# Access Compliance Report

## Public Rights-of-Way

Intersection ID: 32316	Main Street: NEW_PROVIDENCE_LN	Cross Street: WOODCLIFF_CT	Location: S
ADA ID: F9CDD60FE373	Ramp Type: PerpDiag	Initial Pass/Fail: Fail	Overall Compliance: No
Severity Score: 18.75			
Codes/Mitigation Info/Possible Solution		Field Measurements/Component Compliance

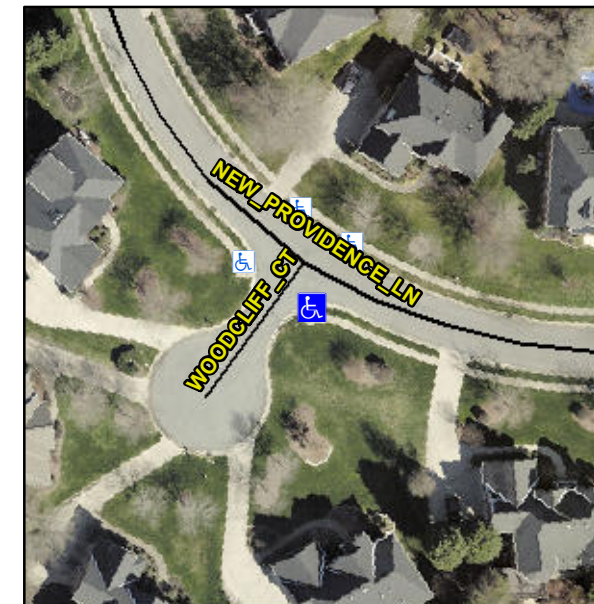
**Not Found, R304.5.1, R304.5.3**

Compliance	Description	Data	Compliance	Description	Data
N/A	Ramp Length (in)	50.5	Yes	Ramp Slope (%)	7.6
No	Ramp Width (in)	35.5	No	Ramp XSlope (%)	3.9
N/A	Flare Type LT	N/A	N/A	Flare Type RT	N/A
N/A	Flare Slope LT (%)	N/A	N/A	Flare Slope RT (%)	N/A
N/A	Flare Traversable LT?	N/A	N/A	Flare Traversable RT?	N/A
N/A	Landing Length (in)	N/A	N/A	DWS Provided?	N/A
N/A	Landing Width (in)	N/A	N/A	DWS Contrast?	N/A
N/A	Landing Slope (%)	N/A	N/A	DWS Length (in)	N/A
N/A	Landing X Slope (%)	N/A	N/A	DWS Full Width?	N/A
N/A	Landing Curb? (Y/N)	N/A	N/A	DWS Offset (in)	N/A
N/A	Shared Landing?	N/A			
N/A	Gutter Ponding?	N/A	N/A	Gutter Slope (%)	N/A
N/A	Gutter Lip Ht (in)	N/A	N/A	Gutter X Slope (%)	N/A
N/A	Painted X Walk1?	No	N/A	Painted X Walk2?	No
	X Walk 1 Direction	To NE		X Walk 2 Direction	To NW
N/A	X Walk 1 Width (in)	N/A	N/A	X Walk 2 Width (in)	N/A
	X Walk 1 Slope (%)	0.5		X Walk 2 Slope (%)	1.3
	X Walk 1 X Slope (%)	3.8		X Walk 2 X Slope (%)	4.2

**Remove & Replace Curb Ramp With Two New Directional Ramps or Equivalent.**
